RE: AK Planning letter dated 15 July 2021 re PP2/21 at 253-267 Pacific Highway, North Sydney

RESPONSE TO DEP FOR

253-267 PACIFIC HWY, NORTH SYDNEY 09/07/21

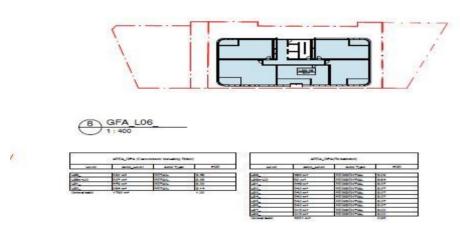
Concern is raised regarding the level of articulation to the towers. In this regard, the ADG recommends that typically a building envelope should be 25%-30% greater than the achievable FSR. It appears that the proposed envelope equals the proposed FSR.

The applicant is requested to demonstrate how the Concept Reference Scheme arrived at the proposed FSR. What is the Gross Building Area (GBA) and what is the efficiency rate applied? Provide an analysis similar to the Conybeare Morison analysis (p53 of Civic Precinct and Surrounds Planning Study) or demonstrate in plan form how articulation of the envelope has achieved the proposed FSR/yield (noting that most of the balconies are counted as GFA because they are enclosed / wintergardens).

We can confirm that the proposed envelope does not simply equal the FSR.

As per your request we have created a table representing the CM format. The table shows the efficiency of the planning proposal at approximately 82 %. For comparison purposes the CM plus

study had an efficiency of circa 80 %. This indicates that the outcome is within industry standards.

The ADG envelope reference you highlight is a generic rule of thumb and is applied by government when undertaking precinct wide strategic planning, the St Leonards/Crows Nest Planning Strategy by Department of Planning is a case in point. For landowner led planning proposals given the level of scrutiny know applied to reference schemes, warrants close to a DA level of envelope planning and design. In this instance we have progressed a design outcome well beyond a hypothetical circumstance as we have recognized the unique site constraints that this site exhibits and hence why the efficiency rate is slightly higher than the ADG rule of thumb. We believe we have demonstrated that the efficiency outcome should be achievable as we progress through the next steps of design.

PACIFIC HIGHWAY ELEVATION

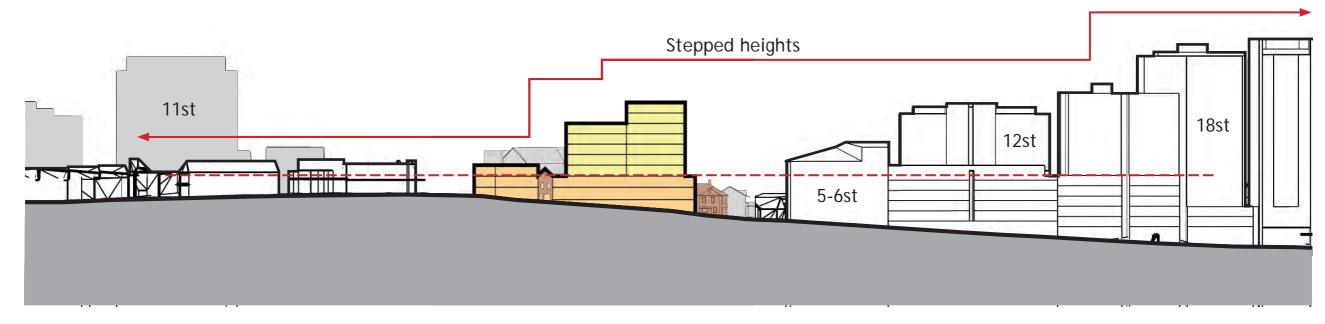
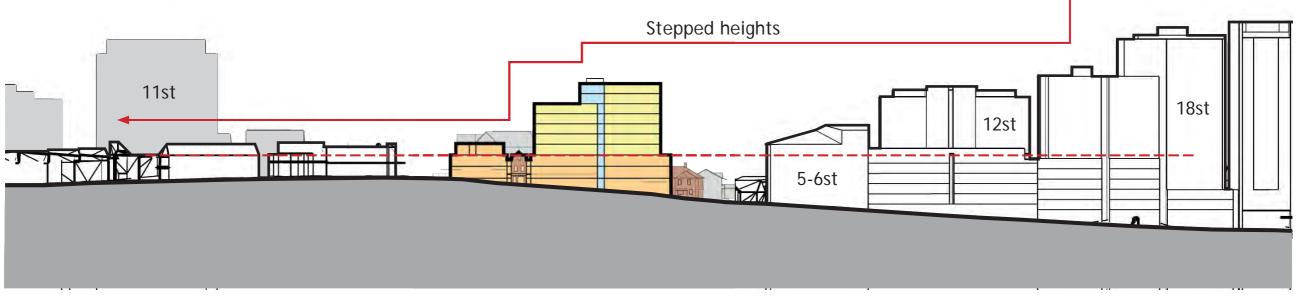
The Concept Reference Scheme does not allow the podium to step down Pacific Highway. Whilst it is acknowledged that the Concept Reference Scheme does achieve the 3 storey street wall height recommended under the CPPS (aligning with the streetscape to the north) the continuation of the podium results in a massing which dominates the contributory item to the south at No. 6-8 McLaren Street.

There is a potential to pay homage to the original streetscape pattern by breaking up the continues street wall. This would also alleviate the massing presented to No. 6-8 McLaren Street. The rhythm and scale should be different from the developments to the south, since the site is not part of the contiguous CBD.

As you have acknowledged the study guidelines indicate a 3-storey podium and we are seeking to respond to that study. We believe it is appropriate and practical to adopt this podium massing as it reflects the form along pacific highway which in our view should not be ignored but continued as you transition to the north.

In relation to the podium design itself you will see in the reference design (extract below) that the notion of stepping is expressed by the awning design and the inclusion of a waist at the podium level. Further work will be done on this during design development leading to DA. At that time matters of materiality, articulation and fenestration design will be addressed.

COMPARISON OF THE TWO SCENARIOS VIEW 1 - CORNER OF CHURCH ST & MCLAREN ST

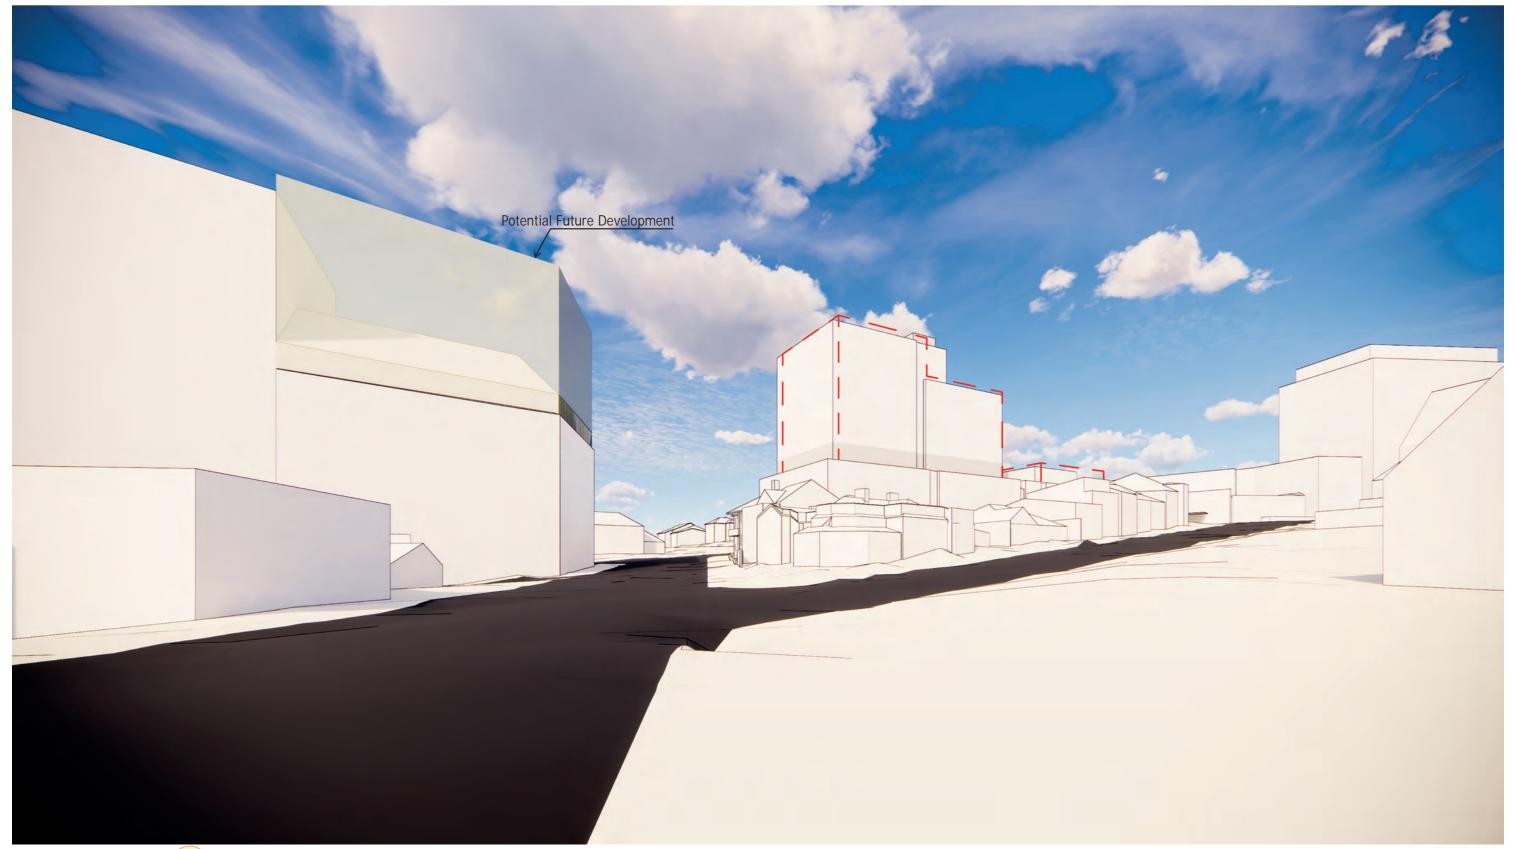
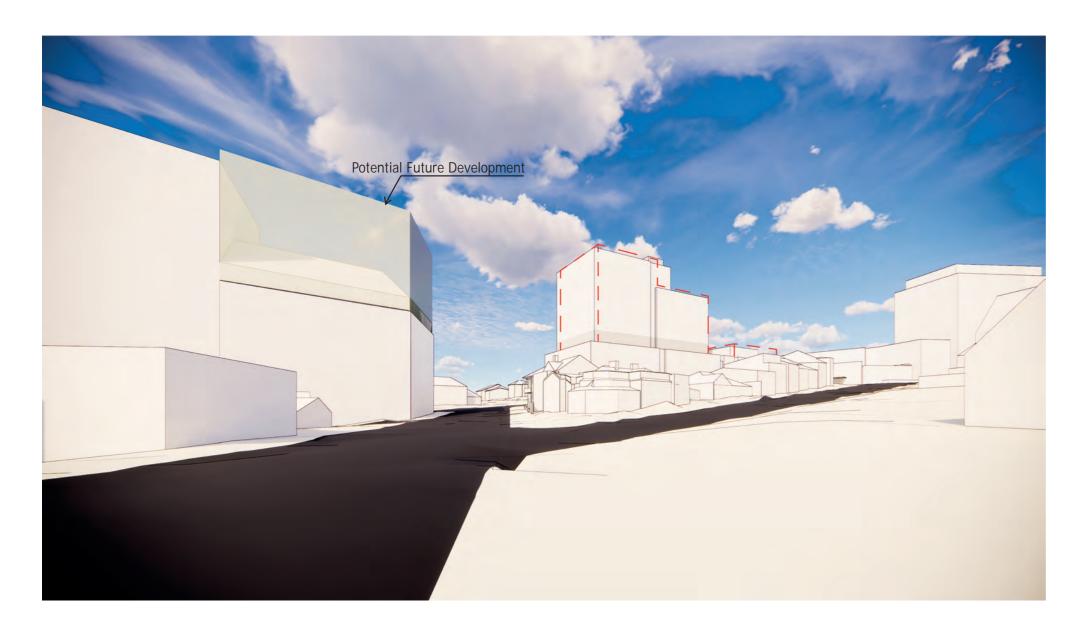
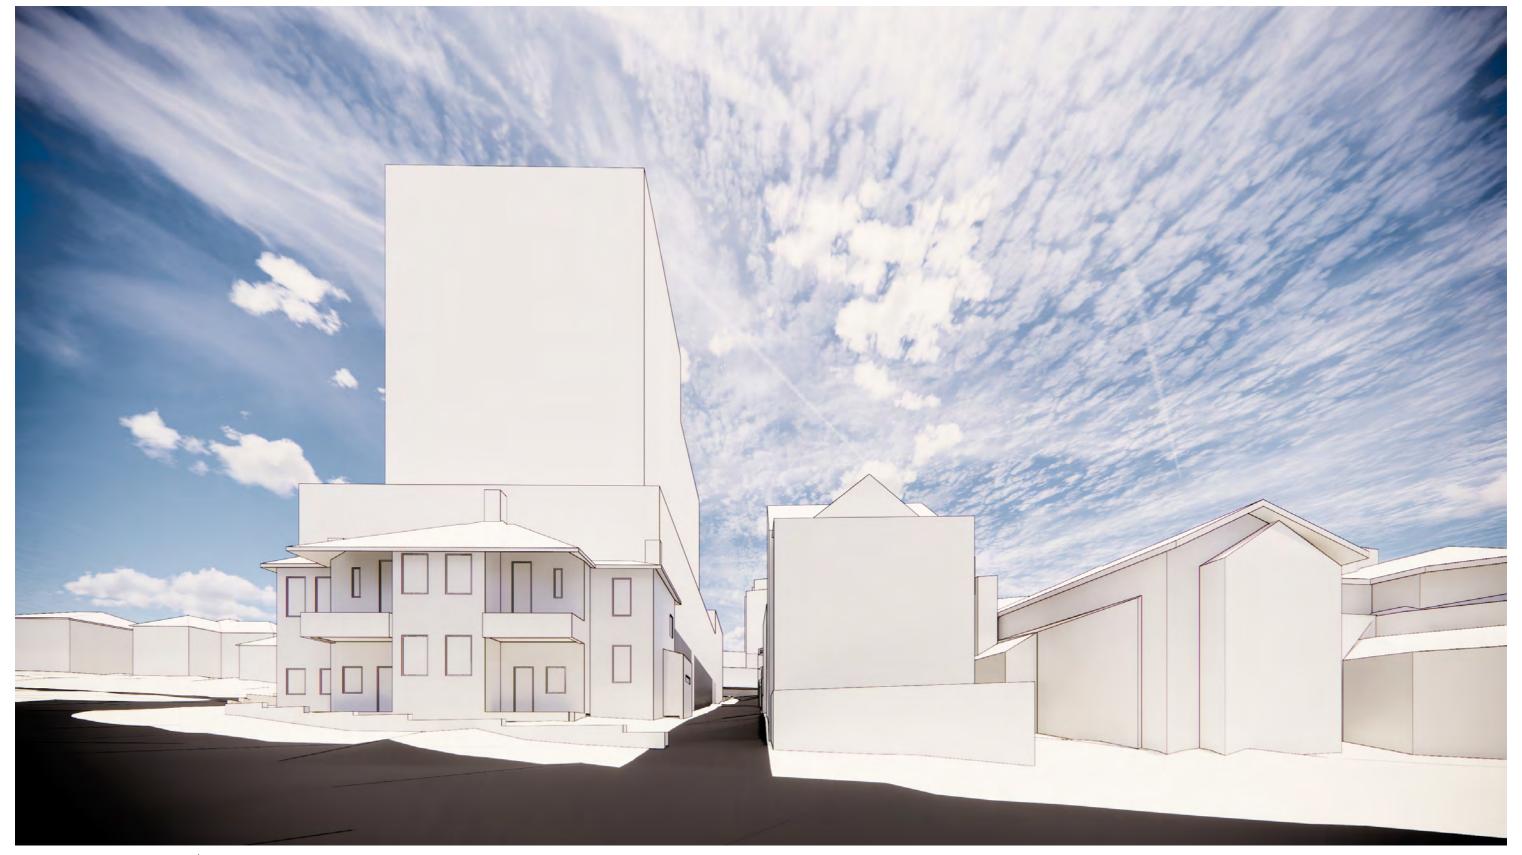
In addition, the Concept Reference Scheme demonstrates that a conventional podium and tower form is incongruous with Nos 6-8 McLaren Street, resulting in a massing which dominates Nos. 6-8 McLaren Street. The documentation submitted does not adequately address the impact on the contributory item, nor how this item could in the future be incorporated into the development.

In addition, McLaren Street has been identified as an important visual corridor. It is recommended that a vista analysis along McLaren Street looking west, towards the site be submitted.

It is recommended that additional massing studies be provided illustrating the proposed built form/visual massing as viewed from the surrounding lower scale R3 zoned land (the adjacent McLaren Street heritage conservation area), consistent with the request by the Design Excellence Panel.

- -Tower bulk is moved further away from laneway.
- -Northern bulk is further setback on its upper level. Both provide more sky view to Church Lane and McLaren St Precinct.
- -Additional articulation zones provided.
- -Vertical indent added to tower, to separate 8 and 10 storey elements.
- -Same setback to South against contributory item on McLaren St.
- -Tower bulk is moved further towards the highway.

-Better to setback further on the more sensitive laneway than on the Highway, and better to setback to the Northern upper level.

ADDITIONAL OVERSHADOWING ON NORTH SYDNEY PUBLIC SCHOOL FROM THE PLANNING PROPOSAL COMPARED TO THE COUNCIL ADOPTED BUILT FORM 1ST JULY 2019, SHADOW CAST AT 10am (WORST CASE SCENARIO)

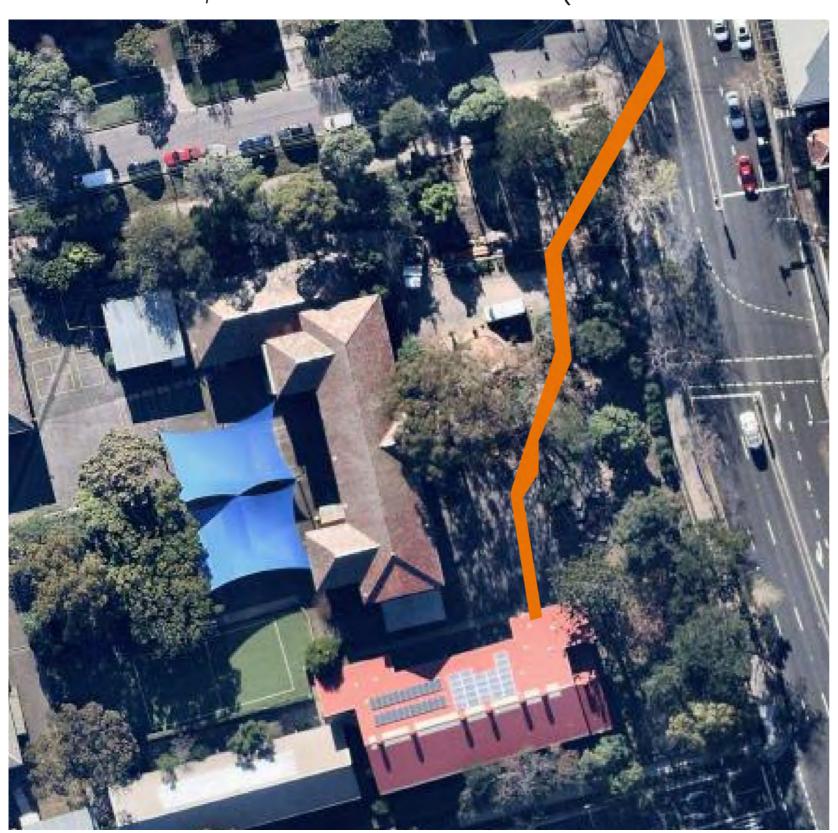
The Planning Proposal report prepared by Urbis states:- "the proposed building envelope will not result in any additional overshadowing to the playground as envisaged under the CPPS". However the shadow analysis prepared by PTW demonstrate Additional overshadowing beyond the existing school buildings.....In addition please confirm whether the shadow analysis include the additional 1m as annotated on the plans for roof services.

We acknowledge that there is a very minor encroachment outside operational school hours and point out that this minor additional encroachment into outdoor asphalt space disappears by 8.45am well before school starts.

We apologize for this oversight. We do not believe this is materially detrimental to the school and wish to point out that the council endorsed envelope would also have a minor additional encroachment.

The shadow analysis does not include the addition 1 m of plant space as it is assumed that any translucent screen or plant will be set well back from the building edge thus avoiding any impact of additional shadows.

Note that the majority of additional shadow cast by the PP (being closer to the highway by 2m) falls on tarmac and/or areas in shadow already from existing trees.

The additional shadow is only as a result of smaller setback proposed in planning proposal, the building height of the council adopted built form and planning proposal model are the same.
